RE: RESPONSE TO REQUEST FOR ADDITIONAL INFORMATION – DA2024/1079

PROPERTY AT 53, 53A AND 53B WARRIEWOOD ROAD, WARRIEWOOD

Reference is made to DA2024/1079 which seeks development consent for community title subdivision into five (5) lots and civil works at 53, 53A & 53B Warriewood Road, Warriewood (the Subject Site).

Proposed Community Title Subdivision – DA2024/1079

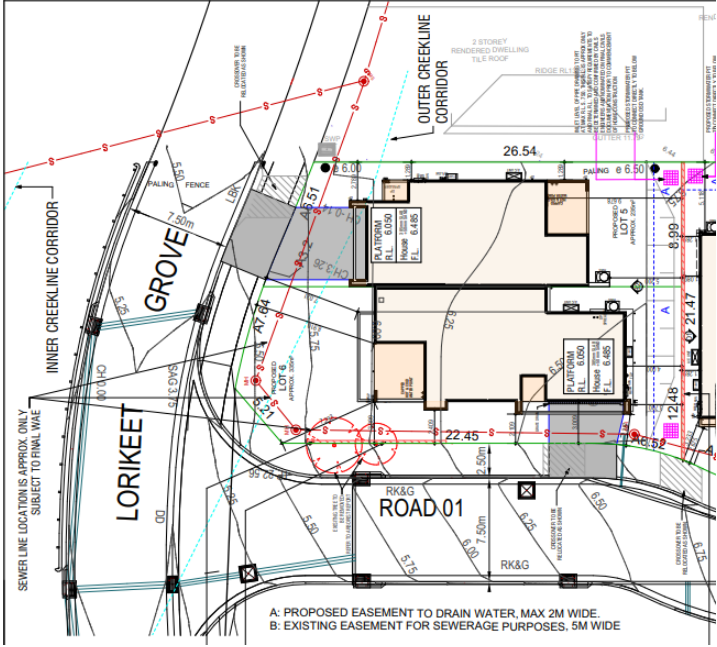
<ul style="list-style-type: none"> The 2.5 metre wide sharepath located within the outer creekline corridor must be located above the 20% AEP flood level and must adjoin with the existing approved sharepath location(s) on adjoining allotments. 	As shown on the revised Civil Engineering Plans provided in Appendix 3 , the 2.5m wide shared path has been relocated to extend parallel to Lorikeet Grove, connecting to the north and south. The path will be located above the 20% AEP. It is noted that shared paths do not currently exist within the neighbouring developments however we have aligned the pathways to accord with the relevant approvals. Works beyond the Subject Site boundary are expected to be undertaken by other parties.
<ul style="list-style-type: none"> Residential accommodation is not permitted within the creekline corridor. 	<p>All dwellings and garages are located outside of the creek corridor. Boundary fencing and landscape areas for the proposed Lots 4 & 5 result in a very minor encroachment of the outer creek line corridor. This is consistent with the approved developments in Warriewood Valley, including Lorikeet Grove.</p> <p>The proposed front boundary of the proposed Lots 4 & 5 is dictated by the contour of Lorikeet Grove, the required verge and residential boundary of No. 21 Lorikeet Grove and No 2 Ibis Place, Warriewood. The proposal represents in fill development to link and continue the extension of Lorikeet Grove west and east of the Subject Site. The dwellings referenced above are also located in the outer creek line corridor and have been previously approved on this basis and set existing precedence. Enforcing strict compliance in this instance would result in an inconsistent subdivision pattern and reduced streetscape outcomes as the future dwellings would be required to be setback considerably from those approved to the north.</p>

TABLE 1 – RESPONSE TO COMMENTS	
Comment	Response
	<p>The built form Development Application under DA2024/1847 was lodged with Council on 15 January 2025 and shows no habitable built form proposed in outer creekline corridor as shown in extract below.</p>  <p>A condition of consent may be imposed which requires that no habitable built form is undertaken within that area, with the exception of the front fencing and landscaping.</p>
<p>6. Landscape</p> <p><i>The landscape plans are to be updated to include the following information:</i></p>	<p>The Landscape Plans (Appendix 11) have been updated to reflect Council's requested information including:</p> <ul style="list-style-type: none"> 2.5m wide shared path above 20% AEP flood level;

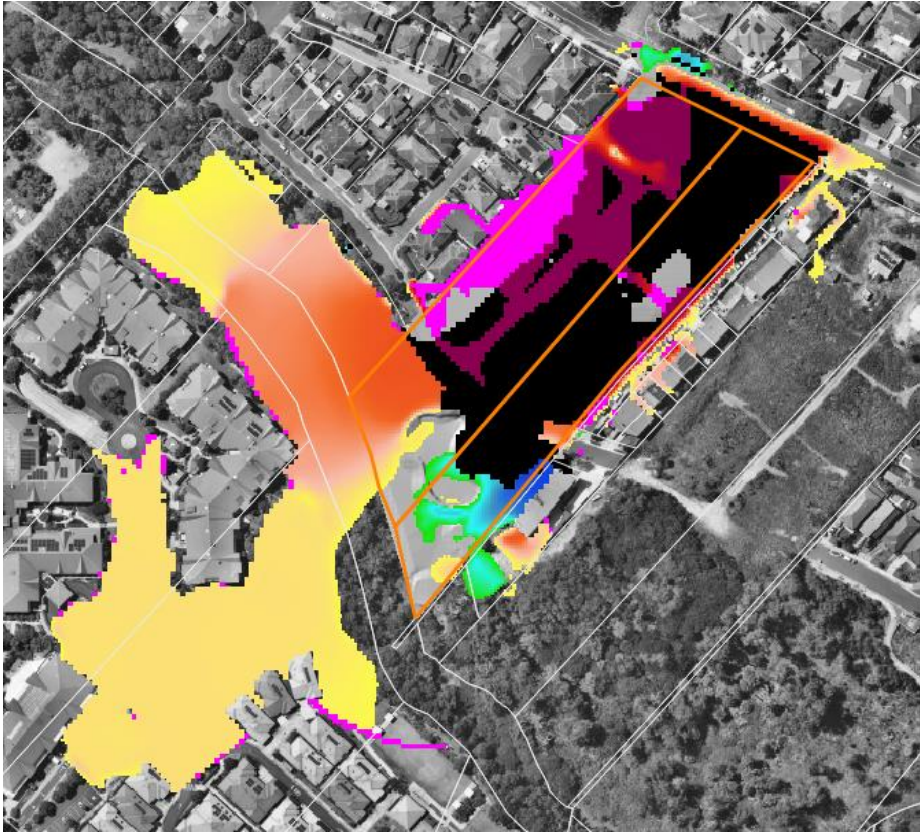
Email Correspondence dated 21 February 2025	
<p>1. Lot 2 is not supportable, another position elsewhere on the site needs to be found. No residential lot west of Lorikeet Grove will be supported. It is my view that the subdivision geometry can be augmented to provide for the requisite number of Lots within the main area of the subdivision.</p>	<p>A revised Subdivision Plan is provided in Appendix 2 which has removed Lot 2 and provides no residential land south of Lorikeet Grove.</p> <p>The proposal offers 31 dwellings consisting of 28 residential lots and 3 secondary dwellings to satisfy the density requirement as represented in the Building Envelope Plan (Appendix 1).</p>
<p>2. It is necessary to relocate the wetland so that no part of it is positioned within the inner riparian corridor. Any wetland that forms part of the development is to be positioned within the outer riparian corridor only. However, and notwithstanding this, where a wetland is located within the outer riparian corridor, its design and position is not to have an adverse impact on the flood storage, as required by the DCP.</p>	<p>Refer to Table 2 below. By way of update, Enspire (Civil) in consultation with CSS (Flooding) have tested both the wetland and raingarden scenarios and advise that flood behaviour AND flood storage would be significantly impacted. Refer to Appendix 12, sketch SK0019 [Raingarden layout] and SK0023 [Wetland layout] for details.</p> <p>CSS confirmed that by incorporating the wetland, adverse flooding impacts were being reported within the mainstream area due to the elevated terrain within the</p>

TABLE 1 – RESPONSE TO COMMENTS	
Comment	Response
	<p>wetland. The elevated terrain is required to design the wetland was a major contributor to the increases in flood levels and adverse flood behaviour. The wetland (or raingarden) essentially acts as an impediment to flow. An image extracted from the preliminary wetland / flood scenario is shown below.</p>

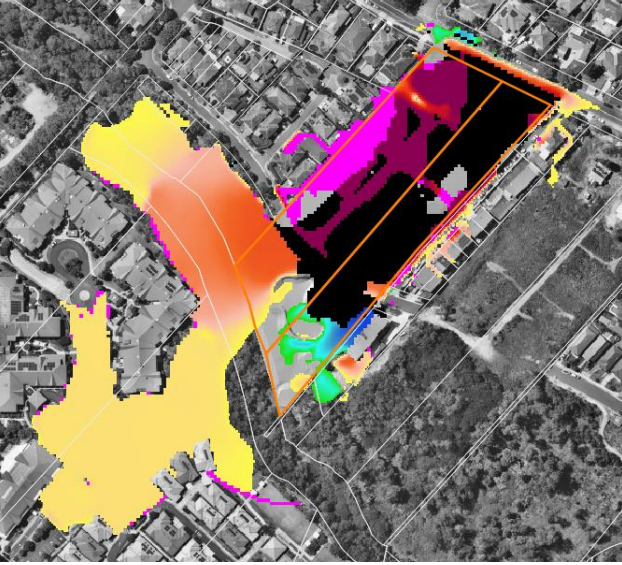
(B) Wetland / Raingarden Solution – <i>Based on discussions with Council</i>	This solution is consistent with what was presented in December's meeting with Council. Enspire agreed to work through a wetland / raingarden solution within the downstream Creekline corridor, provided flooding outcomes could be achieved. The proposed strategy that was agreed in principle involved: <ul style="list-style-type: none"> Introducing an additional crest within Lorikeet Grove which then resulted in 2 'sags' in the road. 	CSS confirmed that by incorporating the wetland or raingarden (Appendix 12), adverse flooding impacts were being reported within the mainstream area due to the elevated terrain within the wetland. It was found that the wetland was a major contributor to increases in flood levels and adverse flood behaviour. The wetland or raingarden essentially acts as an impediment to flow. An image extracted from the preliminary wetland / flood scenario is shown below.

Option / Solution	Civil Engineering Assessment	Flooding Outcomes
	<p>Existing road levels maintained to the north and south (within existing developments);</p> <ul style="list-style-type: none"> Proposed wetland infrastructure similar to that presented in SK0023. Refer SK0023 for an indication which was issued to Council; Provision of a GPT upstream of the wetland, although inundated in various flood events; and Construction of a maintenance access ramp to the wetland. <p>Enspire worked through the above strategy, including a revised 3D terrain model which was then assessed by CSS (Flooding) to determine flooding impacts. Refer column adjacent for outcomes.</p> <p>As a result of flooding outcomes (right), and due to site constraints, i.e., required location and levels of Lorikeet Grove, location of existing sewer carrier mains within the inner/outer creek line corridors, location of existing trunk drainage main, limited area available for ‘flood storage’, and the requirement to have lots located above the relevant flood levels, it is therefore not feasible for a wetland and raingarden to be incorporated into the Subject Site. The wetland or raingarden would also be inundated in majority of storm events.</p>
